# **Final Independent External Peer Review Report for the Savannah Harbor Expansion Project General Reevaluation Report**

Prepared by  
Battelle Memorial Institute

February 11, 2011

**Figure 1. EFDC Model Domain and Boundary Condition Locations. Source of map: EFDC\_Explorer5 (Craig, 2010)**

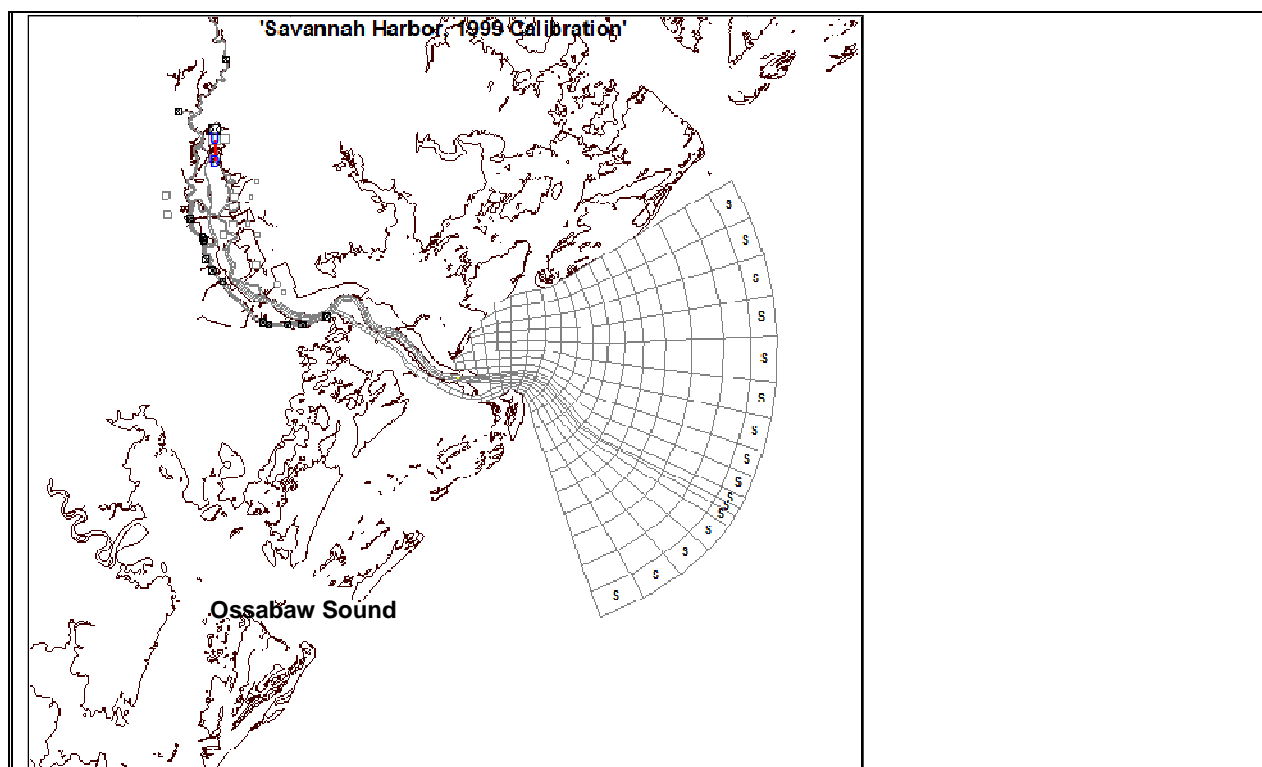
Using the visualization capabilities of EFDC\_Explorer5 (Craig, 2010), inspection of the **efdc.inp** input files used for the 1997 and 1999 model runs shows that the open water boundaries assigned for the EFDC model are defined only by the curved arc boundary. An open water boundary has not been defined for the southeast line from Tybee Island. Figure 1, prepared with EFDC\_Explorer5, shows the flow boundary conditions (marked by black squares) and the open water boundary condition (marked by S) assigned for the EFDC model. The grid cell map clearly shows the south [S] open water boundary along the curved arc of the model domain. The grid cell map also clearly shows that an open water boundary has not been defined for the southeast line from Tybee Island.

The impact of the existing EFDC model setup is that an infinitely high barrier in the ocean is implicitly defined that does not allow flow and mass transport across the southeast boundary line. Although this is a technical issue for the credibility of the model setup, it is unlikely that the project recommendation based on the overall evaluations of the adverse impacts and the effectiveness of mitigation options would be affected by this issue.

1. Extend the existing curved arc to a location south of the Savannah River in the vicinity of Ossabaw Sound (see Figure 1).

**Figure 1- Location of SABSOON stations (Source: Tetra Tech, 2004)**

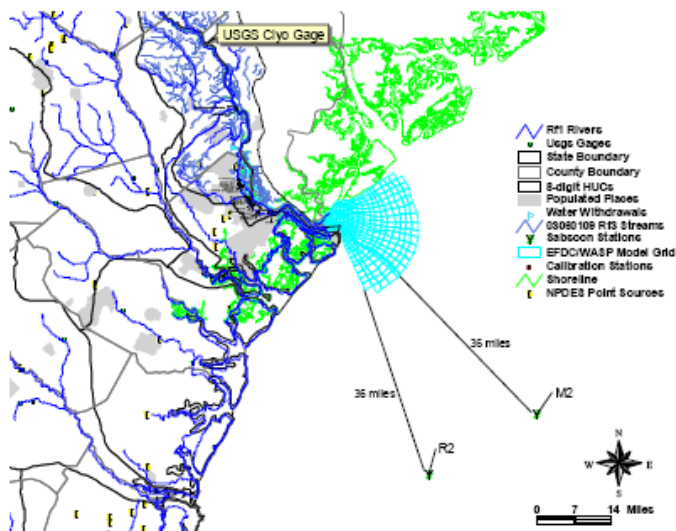
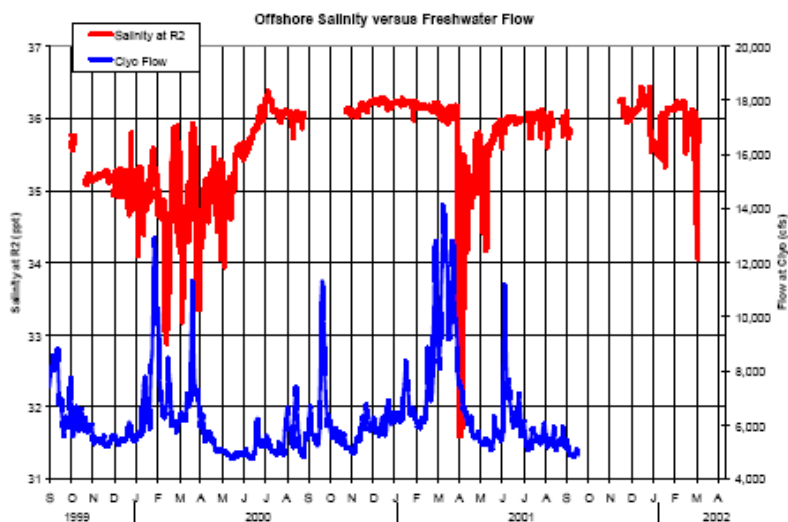
The impact of the existing EFDC model setup is that the technical credibility of the hydrodynamic model is weakened by assigning the open water boundary for the model domain within the inner shelf region where salinity is known to be influenced by river discharge. In a draft report prepared to document the development of the EFDC model of Savannah Harbor (Tetra Tech, 2004), data are presented, and included in this comment, to illustrate the effect of river flow discharging to the SAB on coastal salinity. Figure 1 shows the location of SABSOON Station R2, and Figure 2 shows the time series response of salinity at this station to Savannah River flow from 1999-2002. If sufficient time series observations were available to describe the variability of surface and bottom layer salinity in the vicinity of the open water boundary for the chloride model time frame of 2001-2009, such as is seen in the SABSOON data set shown in Figure 2, then the existing open boundary location would be technically defensible since actual salinity data, dependent on changes in river flow, would be used for input to the model. Since sufficient time series observations for salinity are, however, not available in the vicinity of the open water boundary, aggregate composite data sets that are not influenced by river discharge must be used to assign the open boundary condition.

The technical credibility of the Savannah Harbor model can be strengthened by moving the open ocean boundary location further offshore out into the mid-shelf region. It would then be appropriate to assign either composite monthly salinity or a constant salinity as a reasonable approximation to mid-shelf coastal ocean forcing for the salinity model of Savannah Harbor and estuary. Although this is a technical weakness for the conceptual model of hydrodynamics for Savannah Harbor, it is unlikely that the project recommendation, based on the overall evaluations of the adverse impacts and the effectiveness of mitigation options, would be affected by this issue.

The present model setup for the open ocean boundary weakens the technical credibility of the hydrodynamic model because the simulated salinity distributions in Savannah Harbor are controlled by the assignment of observed inner shelf salinity as open water boundary conditions which, as shown in Figure 2, are, in turn, influenced by freshwater discharge from the Savannah River and other coastal rivers in the SAB.

**Figure 3 - Angular deviation from orthogonality for Savannah Harbor EFDC model for (A) extended grid used for 2001-2009 chloride modeling and (B) grid used for calibration (1999) and validation (1997) from 2006 report. Source of map: EFDC\_Explorer5 (Craig, 2010)**

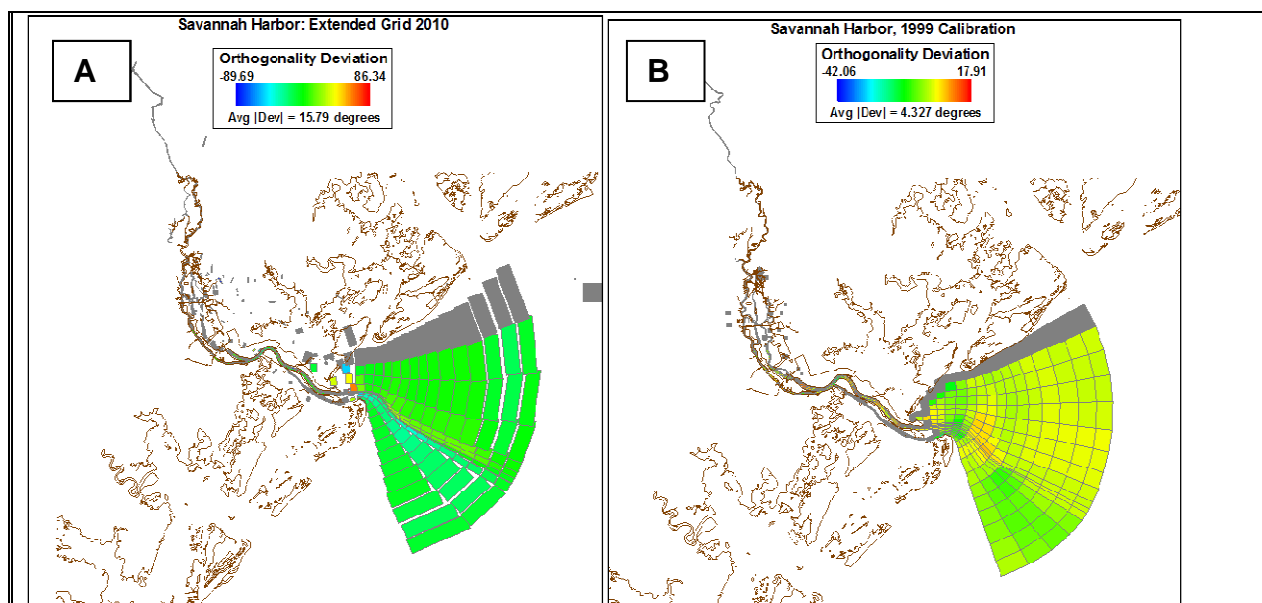
Mapping of Extended Grid Cell Coordinates. The center coordinates of the EFDC grid cells are available in the lxly.inp input file, and the length, width, and curvilinear rotation coefficients are available in the dx dy.inp input file. EFDC\_Explorer5 (Craig, 2010) was used to display the grid cell (I, J) coordinates for the coastal ocean area and the interior of the model domain. The coastal area is shown in Figure 1A and the interior area of the domain is shown in Figure 1B. As can be clearly seen in Figure 1A, several grid cell locations are mapped in the ocean to the east of the open boundary of the model domain. Furthermore, numerous grid cells are mapped to the north of Savannah Harbor outside of the model domain (Figure 1B). In addition to the grid cells shown in Figure 1, EFDC\_Explorer5 (Craig, 2010) was used to display the location of the grid cell for the upstream boundary at Clyo, Georgia. The upstream boundary at Clyo, shown with the red box in Figure 2A, is clearly not mapped at the most upstream location of the upper river, as seen in Figure 2B. The location of the XY Universal Transverse Mercator (UTM) coordinates assigned for the Clyo upstream boundary cell is incorrect, as are the XY UTM coordinates of many other grid cells as shown in Figures 1A and 1B.

**Figure 4 - Bottom layer initial conditions assigned for (A) salinity and (B) chlorides (dye) in the extended grid EFDC model. Source of map: EFDC\_Explorer5 (Craig, 2010)**

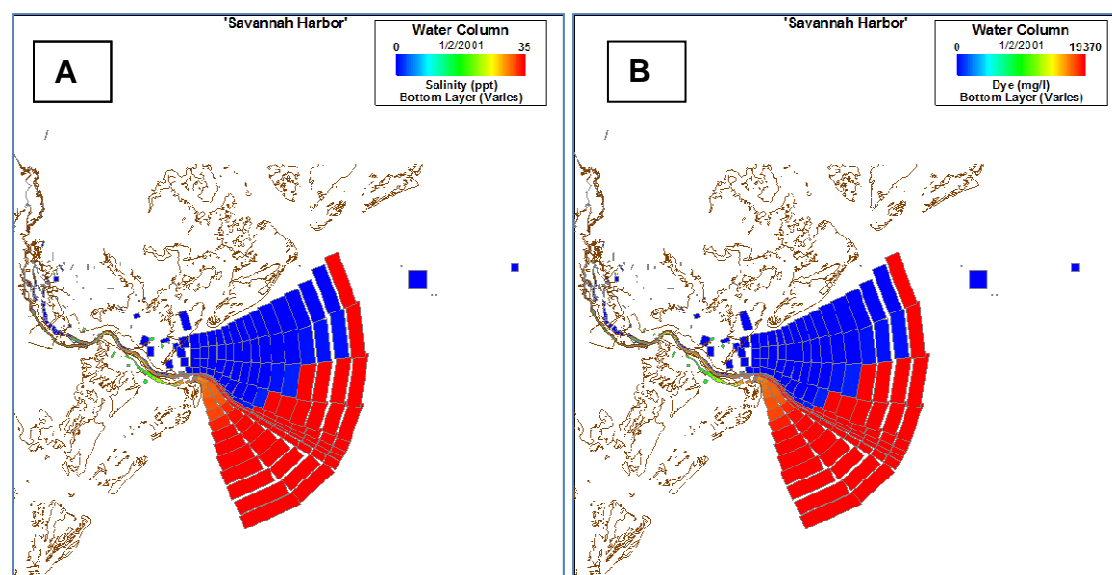
Initial Conditions Assigned for Salinity and Chlorides. Initial conditions are assigned for the hydrodynamic model for water elevation, salinity, chlorides (as dye tracer), and water temperature. Initial conditions are typically based on a spatial interpolation of observed station data to estimate an appropriate initial value for each grid cell and each layer of a model domain. As can be seen in Figure 4 for the initial bottom layer distribution of salinity and chlorides, the grid cells colored in blue identify initial values of zero for salinity and chloride (dye). Similar erroneous distributions for salinity and chloride are also set up for the other layers of the model. Salinity levels of zero for the coastal ocean are clearly not correct.

**Figure 6 - GVC layers setup for coastal area of model domain. Source of map: EFDC\_Explorer5 (Craig, 2010)**

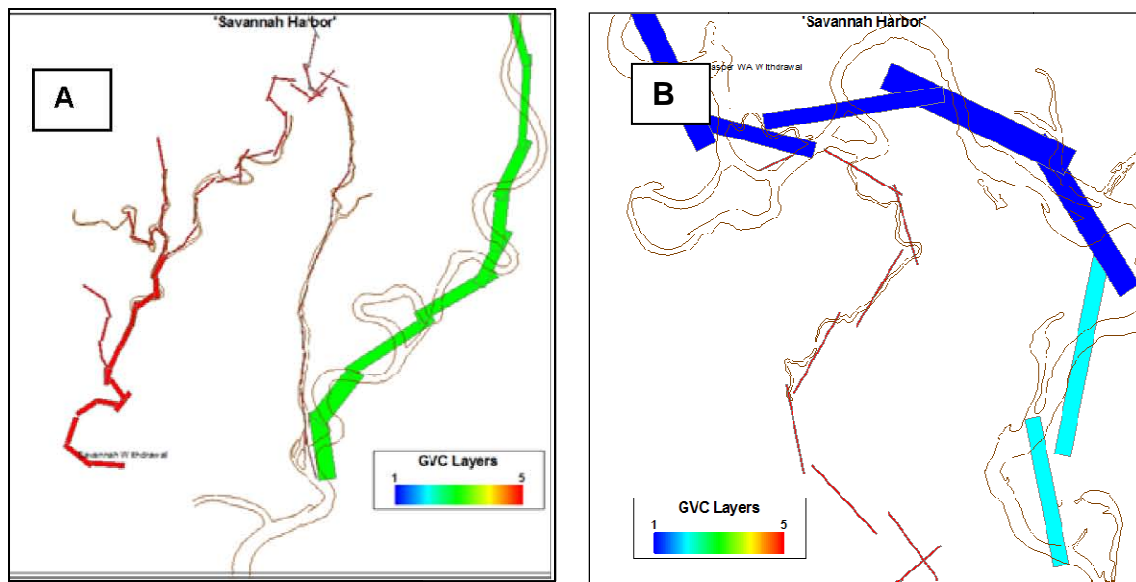
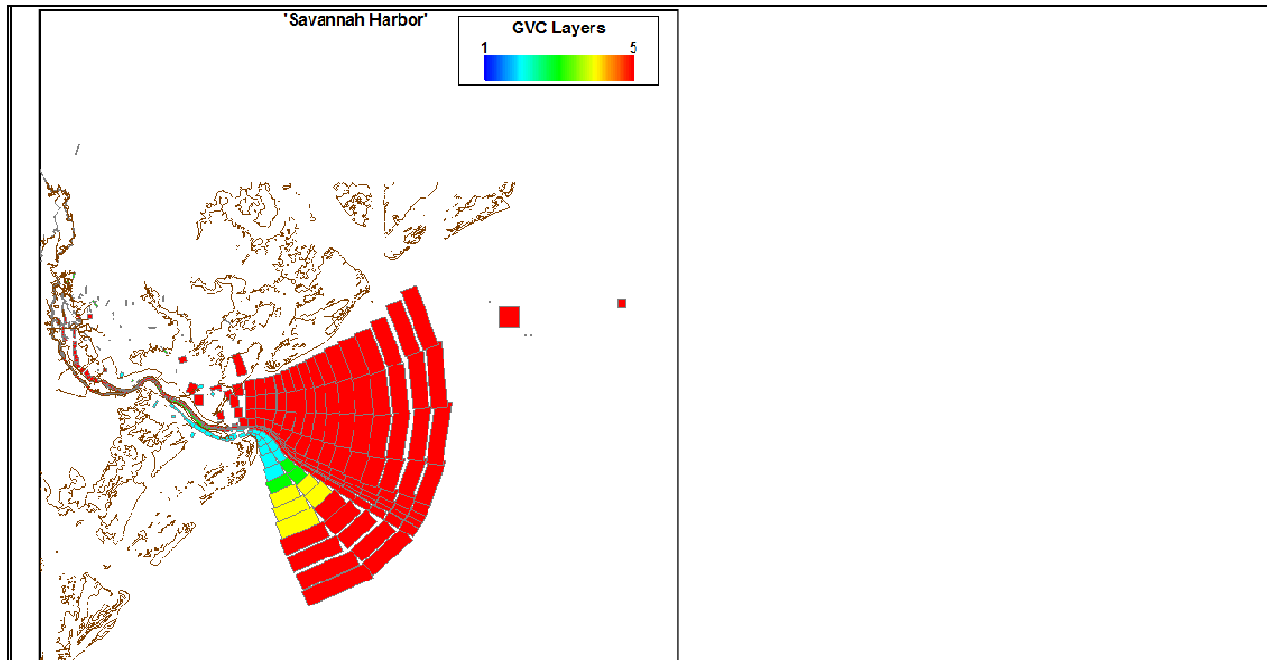
**Z-Grid Representation of Vertical Layers.** As noted in the Chloride Model report on page 6, the extended grid of the model domain was represented using a single vertical layer in the Generalized Vertical Coordinate (GVC) Z-Grid representation. As shown in Figure 5A, Abercorn Creek and the other creeks in the extended grid are represented by red cells in the Z-grid that mark 5 layers. Figure 5B shows that the grid cells for the upper river are represented by blue cells in the Z-grid with a single layer. In terms of the technical basis of the model setup, this representation of the Z-grid is not necessarily a problem. The problem, however, is that the information presented in the report on page 6 is inconsistent with the actual setup of the Z-grid vertical layers of the extended model as identified with the EFDC input files. The information presented in the report should be consistent with the data used for the model setup.

As shown by the red cells in Figure 6, five layers are used to define stratified conditions for the coastal ocean model domain. The blue, green, and yellow cells identify coastal ocean cells defined by two to four layers rather than five layers. An explanation is needed in the report to document why this area of the coastal domain is represented by fewer than five layers since this is inconsistent with the model representation of coastal stratification.

The issues discussed in this comment are technical weaknesses for the setup of the extended grid hydrodynamic model for the Savannah Harbor project that could impact the mass balance requirement for the solution of the deterministic EFDC model. Because the computation of angular deviation is based on cell centroid coordinates, it is likely that the mapping errors identified with the XY UTM coordinates for many grid cells are the cause of the 15.79-degree deviation from orthogonality computed for the extended grid. The grid design is an important component of the hydrodynamic model because a deviation from orthogonality larger than the criterion of 3 degrees can affect the accuracy of the mass balance computations in the numerical solution of the model. The grid issues identified in this comment are problems because mass balance errors could be introduced into the model results due to (a) the erroneous initial condition of zero for coastal salinity and chlorides and (b) the large angular deviation from the 3-degree criterion for orthogonality of the curvilinear grid.

**Figure 1 - Shaded-relief image of the Savannah, Georgia, region. Contour interval (referenced to mean high water): 10 meters. Source: Taylor et al. (2008)**

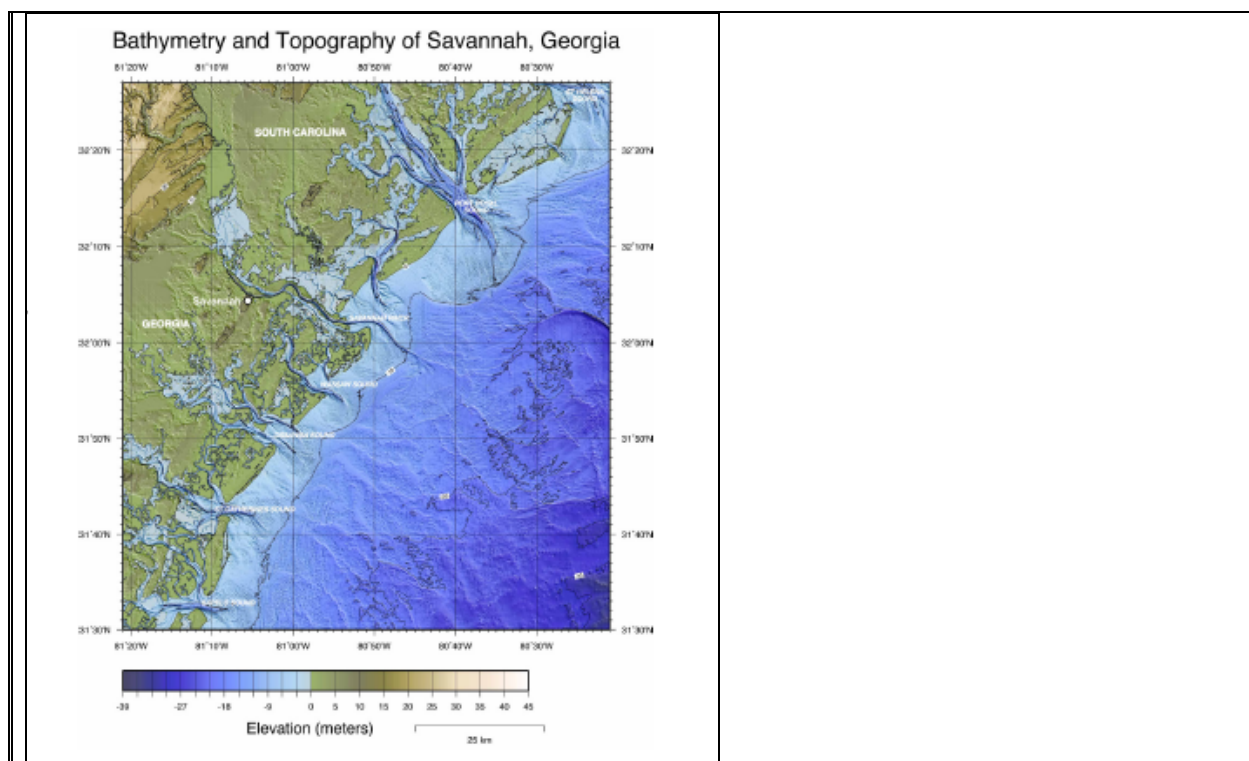
The design of the computational grid for the Savannah Harbor model, based on shoreline and bathymetry data, is, literally, the critical foundation for the development of a technically credible hydrodynamic model, particularly because the model will be applied to evaluate the salinity and water quality impact of changes in volume resulting from channel depth scenarios. Since the grid will determine changes in salinity and chlorides because of changes in the volume of the model domain that are controlled primarily by freshwater flow inputs and tidal forcing, it is essential that the bathymetry and volume of the model grid be confirmed (and revised, if needed) by comparison to a high-resolution DEM of the study area. A discrepancy between the volume of the EFDC model domain and the actual volume of a high-resolution DEM can result in a less-than-acceptable calibration of model results to observed water levels, flow, salinity, and chlorides. If a discrepancy is identified in the model volume, then the predicted impacts of channel deepening and mitigation scenarios on salinity intrusion and chloride levels at the City of Savannah water intake may not be as accurate as possible. The technical credibility of the Savannah Harbor model, and the ability of the model to accurately represent the impact of channel deepening and mitigation scenarios on salinity and chlorides, will be greatly strengthened if USACE is able to present documentation showing a good comparison of volume computed from the model grid and volume computed from a high-resolution topographic and bathymetric DEM.

A high-resolution DEM for Savannah, Georgia, was developed in December 2006 by NOAA's National Geophysical Data Center (NGDC). The DEM was developed to support NOAA's Center for Tsunami Research at the Pacific Marine Environmental Laboratory (PMEL) (<http://nctr.pmel.noaa.gov/>). The 1/3 arc-second coastal DEM, shown in Figure 1, is used as input to a tsunami model developed by NOAA's PMEL. A summary of the data sources and the methodology used to develop the Savannah DEM is given in Taylor et al. (2008). The URL link to the site for accessing the Savannah Georgia DEM is:  
<http://www.ngdc.noaa.gov/dem/showdem.jsp?dem=Savannah&state=GA&cell=1/3%20arc-second&vdat=MHW>

**Comment CL-4:**

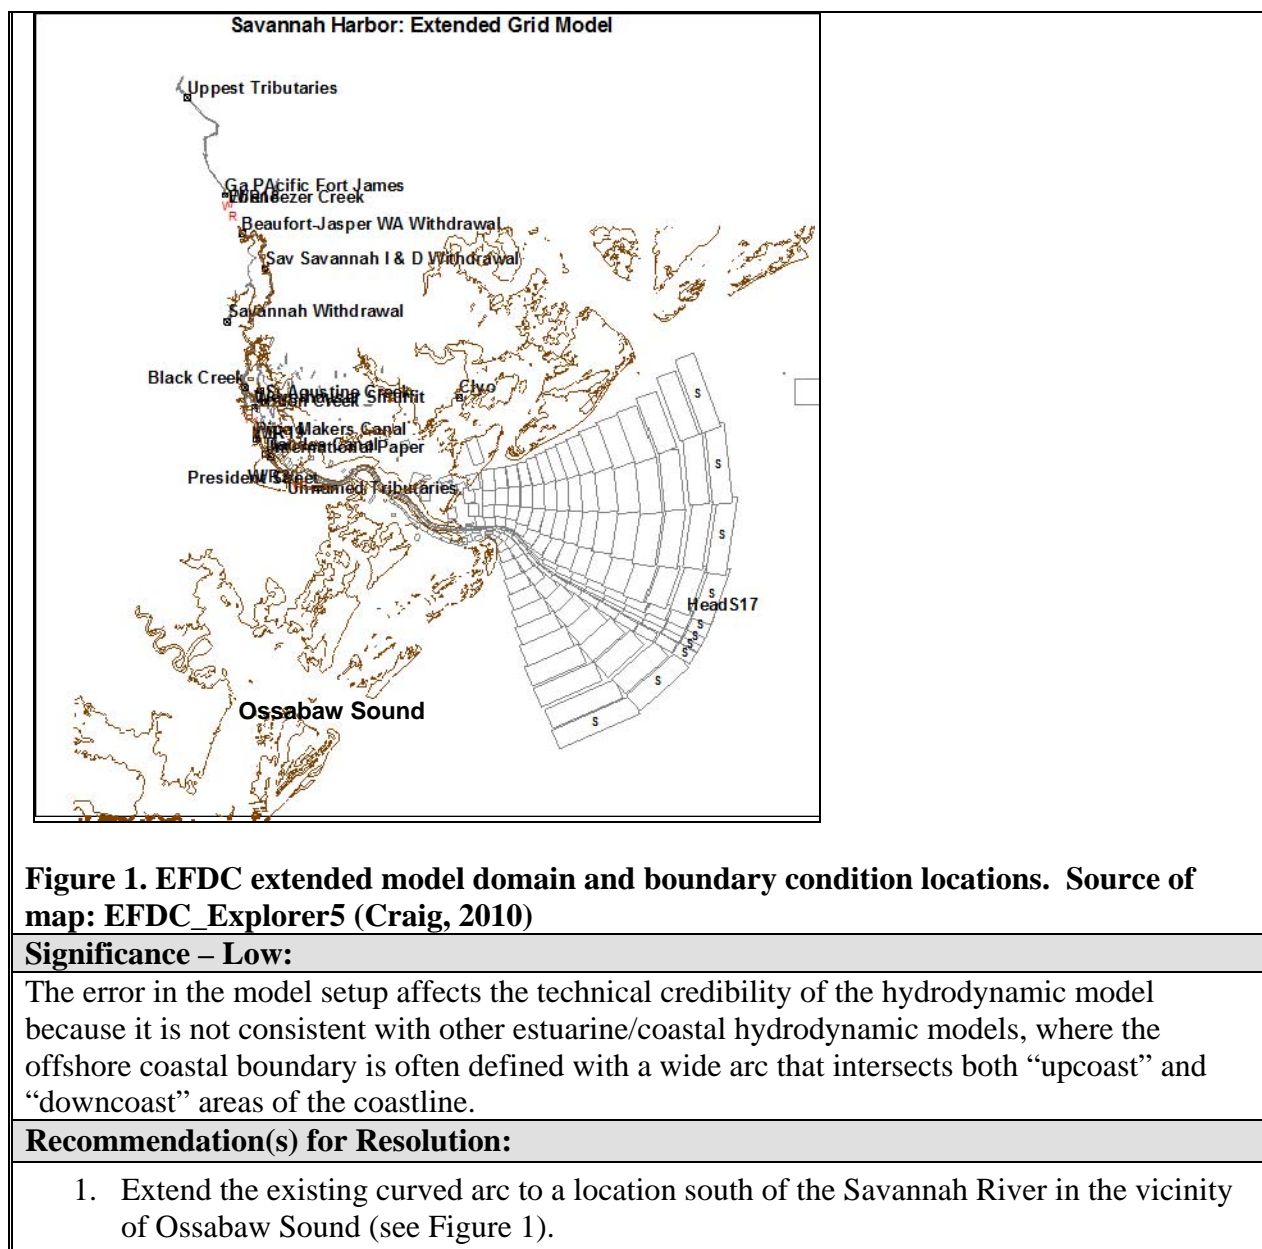
**The EFDC hydrodynamic model setup for the open water boundary condition and representation of the southeast boundary line offshore from Tybee Island has not been defined, causing an infinitely high barrier in the ocean that does not allow flow and mass transport across the southeast boundary.**

As documented in the Chloride Modeling Report, the offshore boundary of the EFDC model domain, located about 17 miles offshore from River Mile 0.0 near Oysterbed Island, includes the existing channel, and proposed extension of the navigation channel. As shown in Figure 4-2 (page 8), the extended grid retains the open water boundary including a wide curved offshore arc and an onshore-offshore transect along a southeast line extending from Tybee Island. An issue that has been identified for the chloride modeling analysis is related to the model setup for the open water boundary along the southeast line from Tybee Island.

Using the visualization capabilities of EFDC\_Explorer5 (Craig, 2010), inspection of the EFDC input files used for the 2001-2009 extended grid model shows that the open water boundary assigned for the EFDC model is defined only by the curved arc boundary. An open water boundary has not been defined for the southeast line from Tybee Island. Figure 1, prepared with EFDC\_Explorer5, shows the flow boundary conditions (marked by labels and black squares) and the open water boundary condition (marked by S) that have been assigned for the EFDC model. The grid cell map clearly shows the south [S] open water boundary along the curved arc of the model domain. The grid cell map also clearly shows that an open water boundary has not been defined for the southeast line in the ocean from Tybee Island.
